N6744B-01

S E R V I C E N O T E

N6744B 100W DC Power Module

Location of C36 and C37

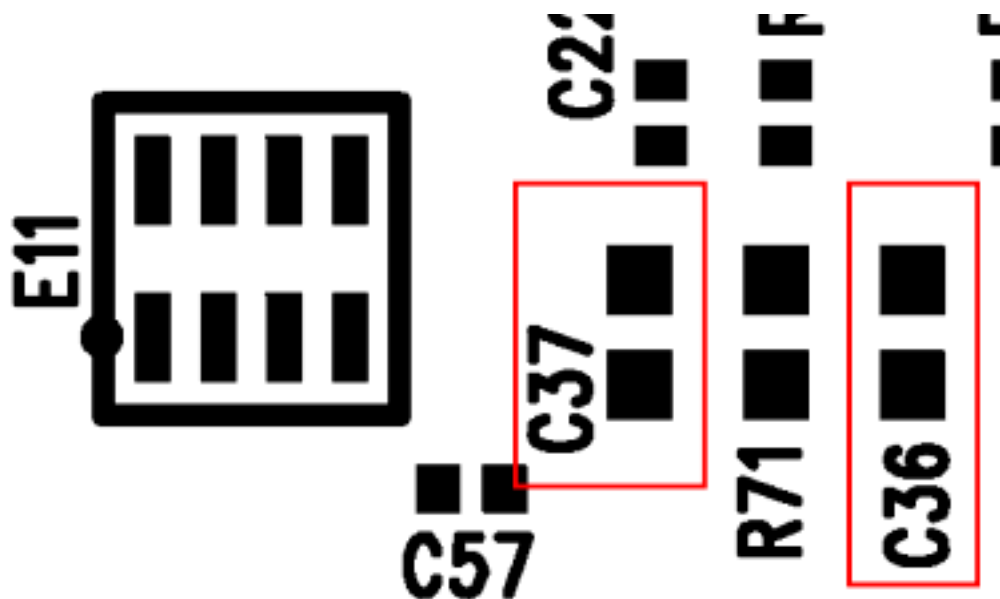
Due to some noise filtering issues, the current measurement accuracy will be out of specification by a fixed offset when there is a voltage being sourced at the output terminals. If the output is shorted, the current measurement accuracy will be within specifications. Please note that the performance verification test will not catch this.

If this measurement is out of specification, replace capacitors C36 and C37 on the DPM assembly (this is the assembly that is vertically mounted in the unit that looks similar to a PC memory module) with part number 0160-7809. After the capacitors are changed, the unit will require re-calibration. After the capacitors are replaced, check the make sure that the unit is in specification by applying 75% of the full voltage range while attached to a load drawing 50 mA to 70 mA. If the current measurement is within the specification, then the unit has been repaired.
